# AGET, a Front End ASIC for Active Time Projection Chamber

### Control of the individual Trigger signals

proposal 1.0, March 25, 2009; Author: P. Baron

Fig 1: Schematic of the trigger signal management.

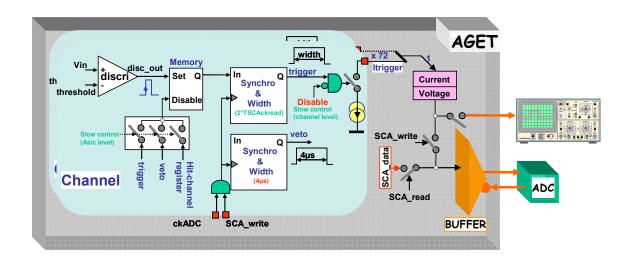
In the case where one or several channels are statistically often hit by the effect of the beam for example, it is important that these channels do not participate to the trigger signal by keeping the possibility to know if they have been hit or not.

The "problem" can be solved by using the slow control to enable or not the individual trigger to the multiplicity signal building (fig. 1). This feature implies therefore an individual bit register of slow control per channel. The discriminator output remains always functional and can be memorized in the hit channel register.
